MUNCIE POWER PRODUCTS

Product Bulletin #00035

Subject: New RVC kit for V080 & V130 valves (for use with detent options)

Date: Feb. 28, 2017

Note:
Number of Items in Detent
Kit will vary depending on
kit in use. (V080BC08 kit shown)

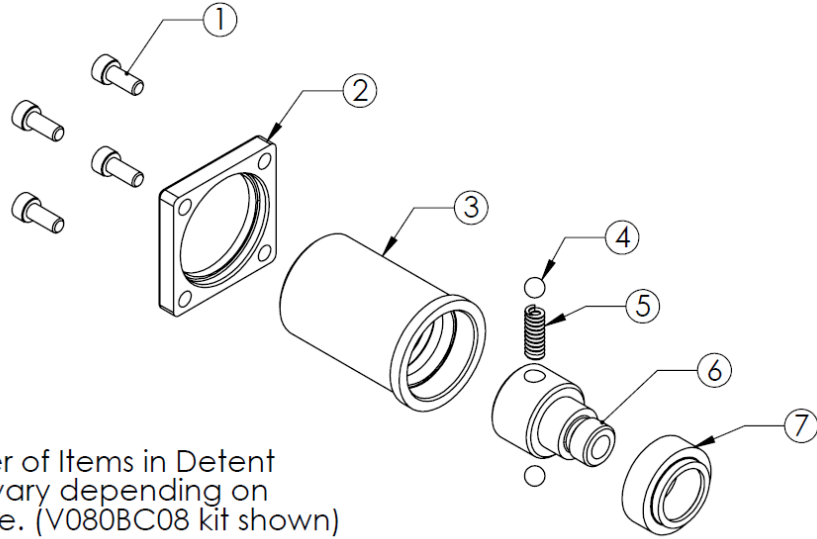
The new RVCHK233S1 was created to reduce the shift force out of the detented position while using a cable shift option. The new RVCHK233S1 kit includes a "soft" detent spring (P/N 0602025333M1) that can be used to replace the "standard" detent spring. Making use of the "softer" spring makes it easier to shift the valve spool back to neutral.

“Item 5” is the detent spring that must be replaced with the new
“soft” spring, P/N 0602025333M1.
